25-32SP Epiphany Cathedral Parking Staff Report

Address:	225 N. Harbor Drive
Requests:	Redevelopment of an existing shell parking lot to a new paved parking lot for Epiphany Cathedral
Owner:	Frank J. Dewane, Bishop of Diocese of Venice
Agent:	Kreg E. Maheu, DMK Associates, Inc.
Parcel IDs:	0175-16-0018
Parcel Size:	±0.85 acres
Future Land Use:	Institutional Professional
Zoning:	Office, Professional and Institutional (OPI)
Comprehensive Plan Neighborhood:	Island Neighborhood
Application Date:	July 23, 2025

Site and Development Plan

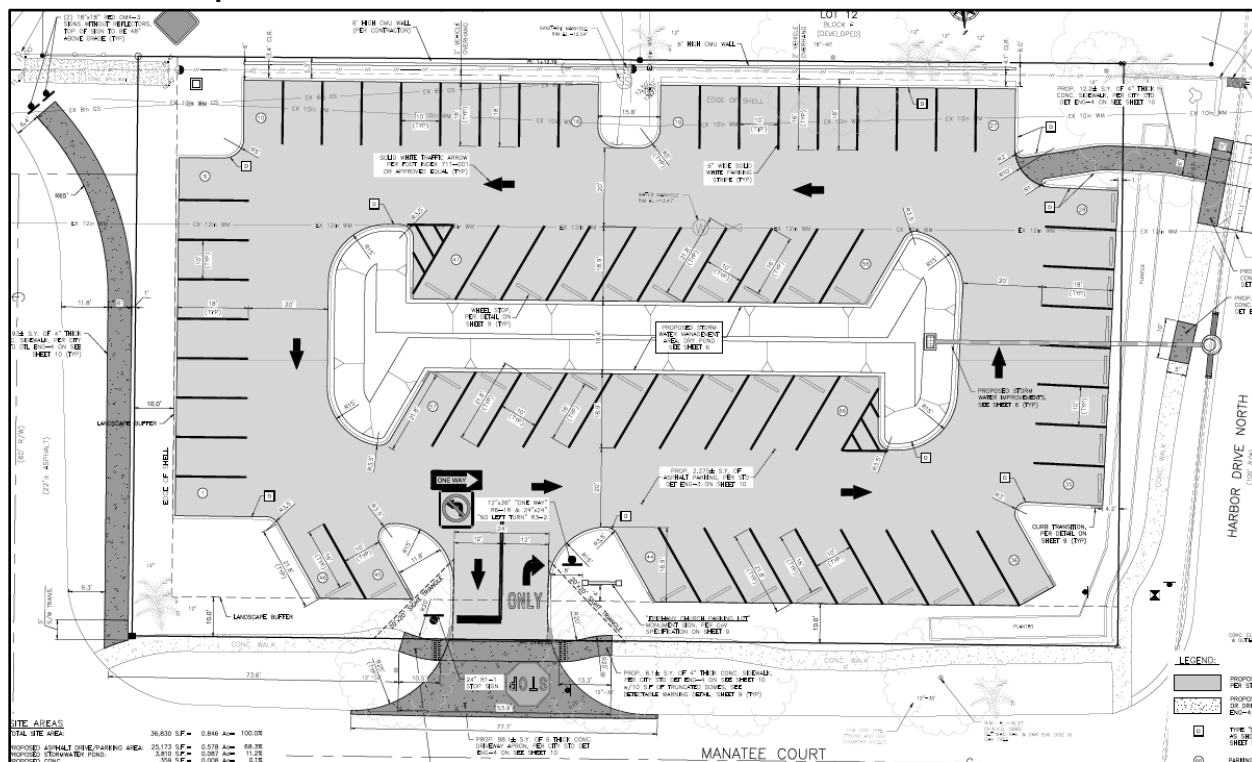
The Site and Development Plan proposes redeveloping an existing shell parking lot into a paved parking lot with landscaping and sidewalks. The parking lot is considered to be a remote parking lot, as defined by Table 3.6.7 in the Code, as it is within 1,000 feet of the principal use structures

(Epiphany Cathedral and School). The proposed project has been reviewed for consistency with the LDC. The proposed plan complies with the LDC and has been reviewed for compliance with regulations on use, parking, lot coverage, lighting, and landscaping requirements, as applicable.

Summary Staff Comment: *The proposed site and development plan proposes to improve the existing shell parking lot to a paved parking lot with sidewalk and landscaping. The project meets all the requirements of remote parking in Sec. 87-3.6 of the Code. The project was reviewed by TRC and found to be consistent with the Comprehensive Plan and the Land Development Code.*
